Planning Application 16/01724: Widening of steps linking the southern end of Southampton University Highfield Campus with Southampton Common

Representation by Simon Hill MRTPI

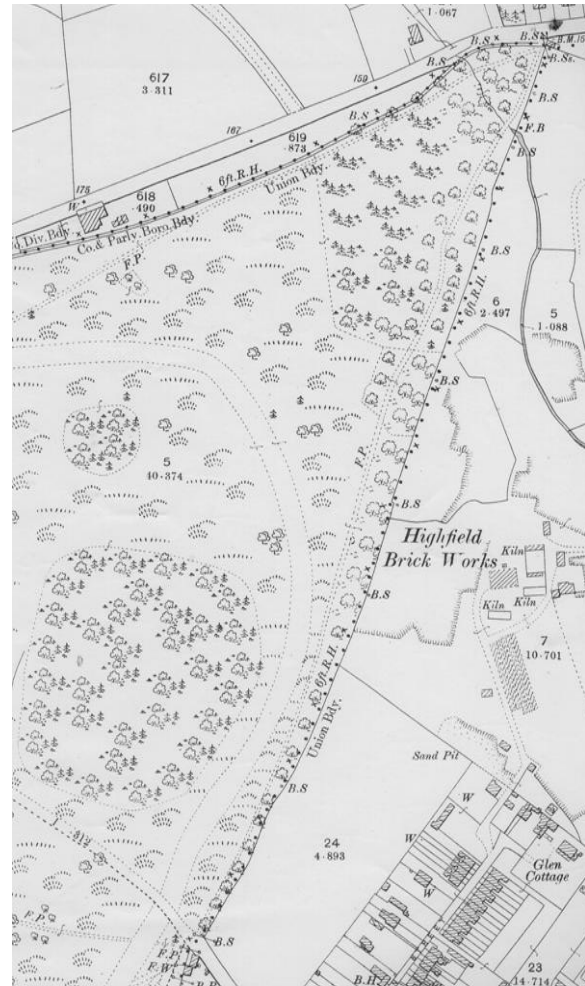
OS maps, e.g. '6ft.R.H.' on extract below of 1898 map (denoting 'root hedge'). The boundaries have thus been a defining landscape feature of the common for centuries, providing a sense of visual containment from within and without¹. They would have been much more prominent on the edge of the open heathland landscape that comprised approximately 80% of The Common until the 1960s, after which, following cessation of grazing at WWII, much of the open landscape became progressively wooded.

15. Approximately at the top of the proposed steps is the site of what, until relatively recently, was part of the medieval ditch and bank that surrounded most of The Common to retain cattle, as shown on the 1846 and 1898 maps above. It appears to have survived, along with the outer boundary stones (as recorded on OS maps of the 1930s – see p.6), in this location well into the 20c and beyond when the University acquired the land adjacent to The Common.

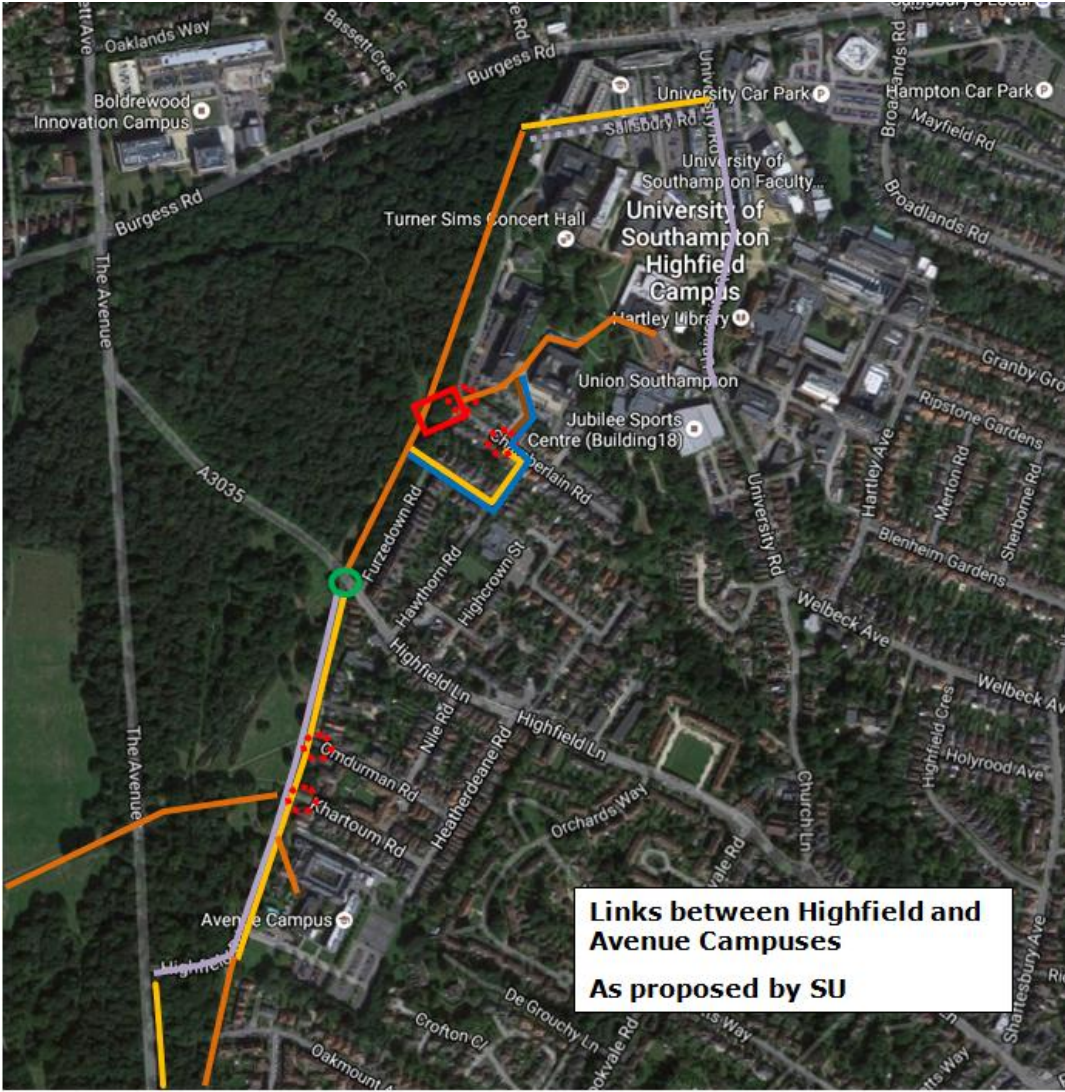
26. The current proposal continues the tradition of talking the walk rather than walking the talk. The link from the south west corner of the campus to the surrounding area is probably the most used of all, as it is access to the Avenue Campus and the direction of the City Centre. Yet, despite cycle troughs, it would be inconvenient for cyclists, requiring them to dismount and push their bike alongside, potentially amongst a large number of pedestrians. It is thus seriously sub-standard measured against the LTP objective of achieving 'a high quality, continuous, coherent cycle network'.

27. Whilst this sub-standard approach might be unavoidable if there were no superior alternative, in this case there is, as fully described in paras. 34-45. Using a ramp (from a point in the above photograph where the left-most car is parked) wholly within University owned land with a 1:20 (5%) gradient over 70m – within the Sustrans national standard - would enable continuous cycling on a segregated/ dedicated route, unencumbered by pedestrians.

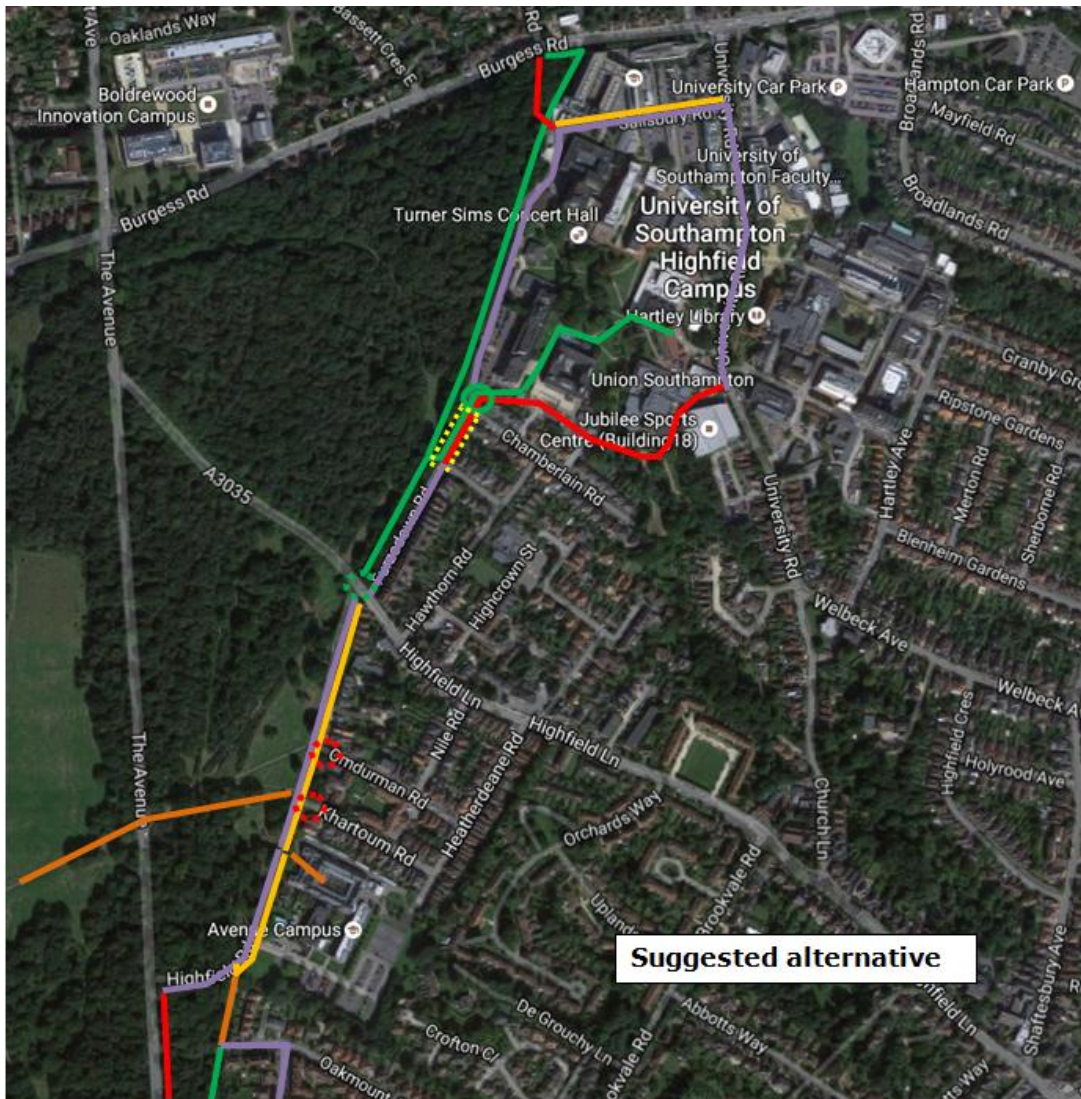
29.The proposal makes no provision for the disabled travelling between the two campuses or accessing the Highfield Campus at its south west corner. Wheelchair/mobility scooter users would have to use the indirect route proposed as the temporary route for all whilst the proposal is implemented. However this is significantly more indirect and inconvenient (illustrated below). If it were not, there would be no need for the steps in any event, as all could follow the temporary alternative route on a permanent basis.

movement in built environments as the able bodied. It is hard to understand how a University can espouse such equality aims in principle but abandon them in practice. The proposed access between its two main accesses discriminates against the disabled by forcing them to separate from colleagues and take a more circuitous, less safe, more time consuming route.

Southampton University Highfield – Avenue Campuses link: Proposed ramp
 (alternative to existing/widened steps)

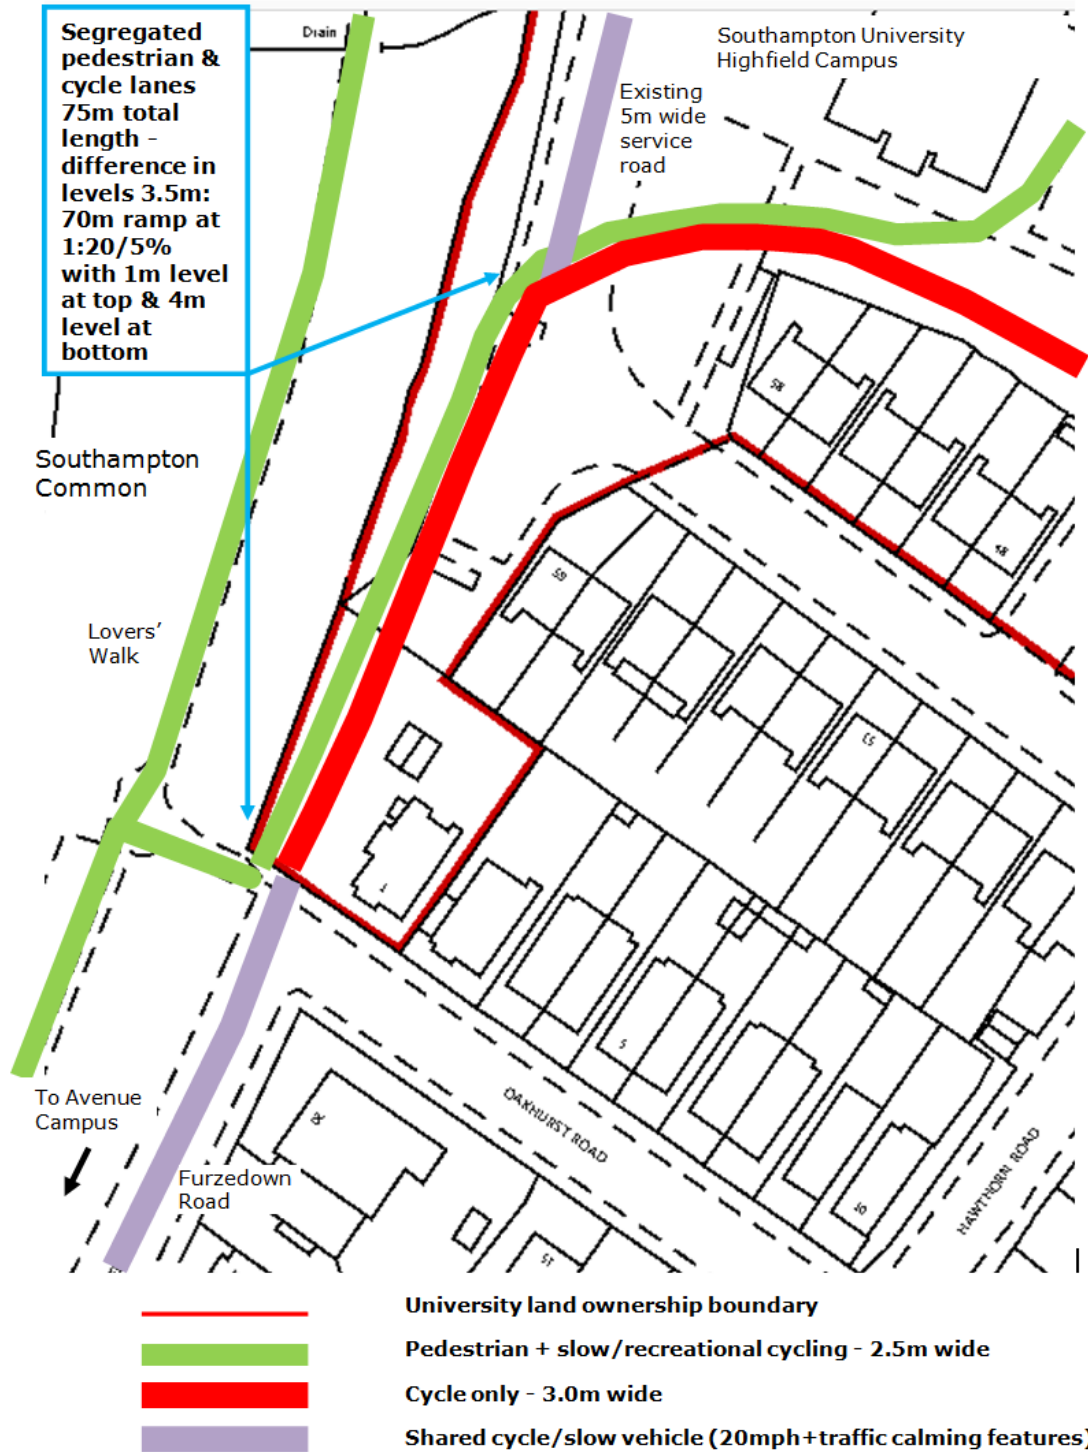
34. Whilst the grossly substandard proposal to widen the steps might have to be accepted if there were no superior alternative, in this case there is. On adjacent land wholly owned by the applicant a sloped ramp, partly in cutting and partly against an existing bank, could be provided at a gradient of accepted standard for pedestrians, cyclists and the disabled (see diagram on next page).

- a. cater for cyclists without needing to dismount, thereby contributing to the aims of SCC's LTP for a 'high quality, continuous, coherent cycle network' and fully according with statutory planning policy LP SDP11;
- b. make an convenient, safe and direct route for the disabled and other users of wheelchairs and child buggies etc, thereby conforming with statutory planning policies LP SDP 11 and CS 13 (9);
- c. segregate cyclists from pedestrians therefore avoiding the conflict and intimidation of pedestrians that can take place on crowded shared routes and which detract from the relaxation of their walk.
